PETITION NUMBER:	0906-VS-07
SUBJECT SITE ADDRESS:	1306 Monmouth Drive
APPELLANT:	Paul Wilson
REQUEST:	The applicant is requesting a variance of development standard (WC 16.04.110, A, 6) to reduce the rear yard setback from 30 feet to 10 feet for lot number 563 (1306 Monmouth Drive)
CURRENT ZONING:	SF-3 Cluster
CURRENT LAND USE:	Single-Family Residential
APPROXIMATE ACREAGE:	0.14
RELATED CASES:	0109-VS-72
EXHIBITS:	1. Staff Report, 06/09/09 2. Aerial Location Map, 06/09/09 3. Property Card, 06/09/09 4. Letter of Grant, 0109-VS-72, 06/09/09 5. Appellant’s Application and Plans, 05/21/09
STAFF REVIEWER:	JCM

MILLER RES.
1306 MOUNTAIN DR
WESTFIELD, IN 46074
SUNROOM ADDITION

SUNROOM ADDITION 1306 MONMOUTH DR. WESTFIELD IN

See Sheet 3 of 3 for Drawing Exhibit

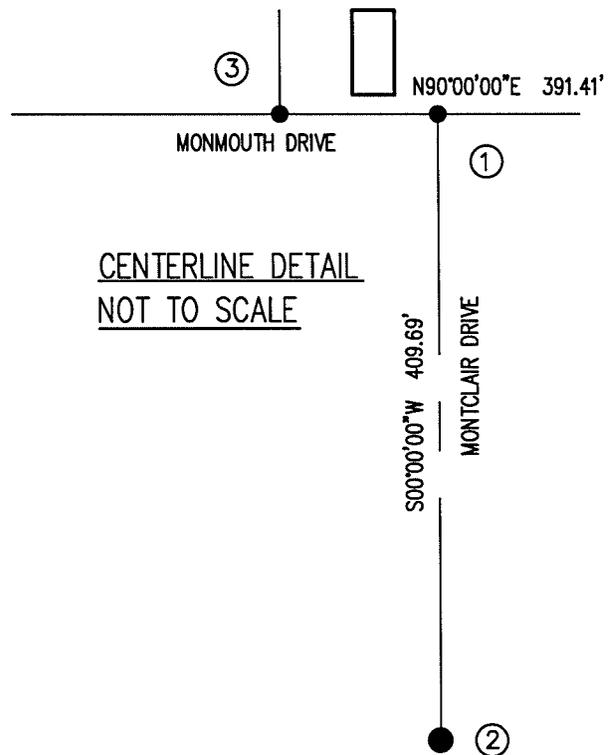
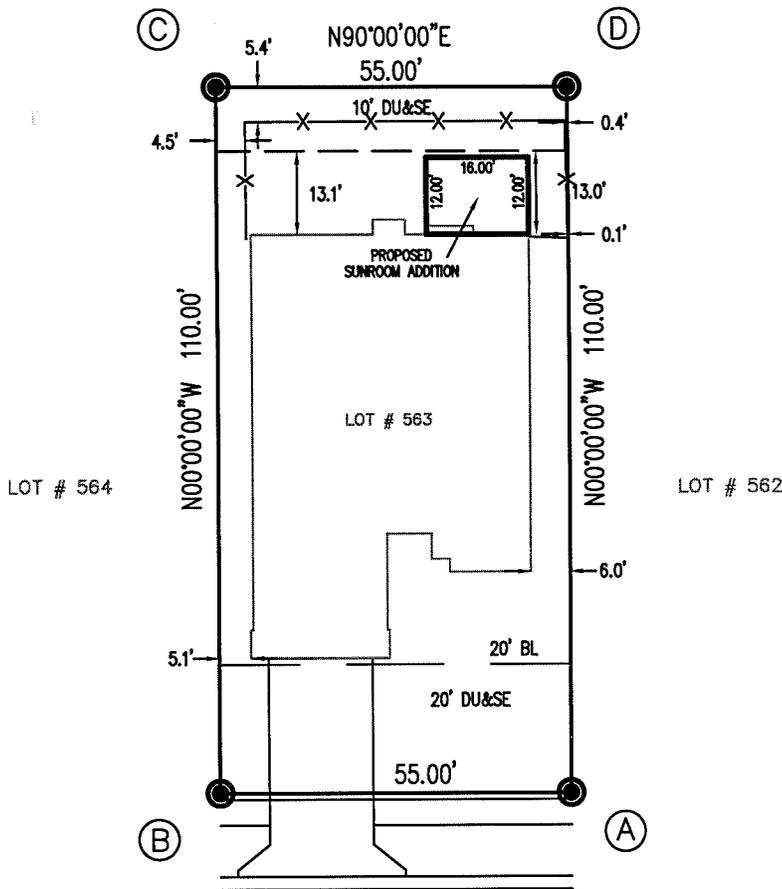
Rear yard setback. The submitted application (the “Application”) includes plans to construct a new 12’x15’8” sun room (the “Sun Room”) on the north side of the Structure, within the Property’s rear yard, as shown in Exhibit 5. The Structure is currently located approximately twenty-three (23) feet from the rear property line (the “Rear Property Line”). The Sun Room would cause the Structure to be approximately ten (10) feet of the Rear Property Line. The Sun Room would encroach into the reduced rear yard setback as approved in the 2001 Variance by approximately 5 feet.

Note: As illustrated in Exhibit 5, a ten-foot drainage and utility easement (the “Easement”) runs along the Rear Property Line. A wood privacy fence is located within the Easement. Fences are not permitted to be installed within the Easement without prior approval. No proof of such approval has been received by staff.
